Access Compliance Report

Public Rights-of-Way

(Curb Ramps)

Intersection ID: N/A	Main Street: MORABLIN_DR	Cross Street: MERSINGTON_LN	Location: SE
ADA ID: A606A8F61BC3	Ramp Type: PerpDiag	Initial Pass/Fail: Fail	Overall Compliance: No
Severity Score: 12.5			
Codes/Mitigation Info/Possible Solution		Field Measurements/Component Compliance

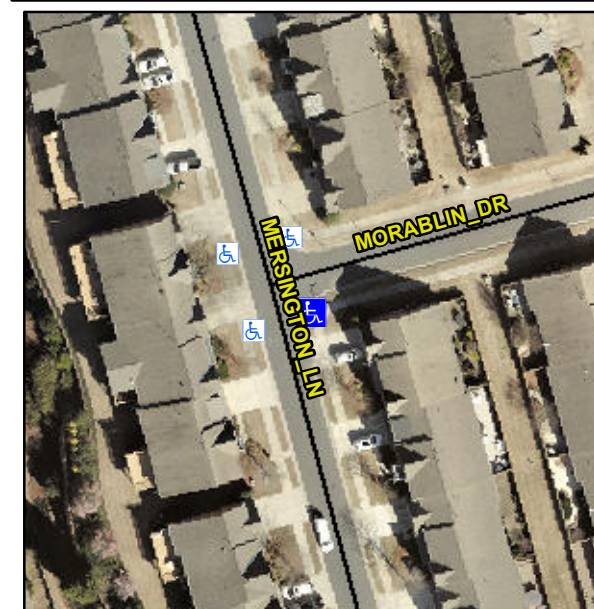
Not Found, R304.2.2

Remove & Replace Curb Ramp With Two New Directional Ramps or Equivalent.
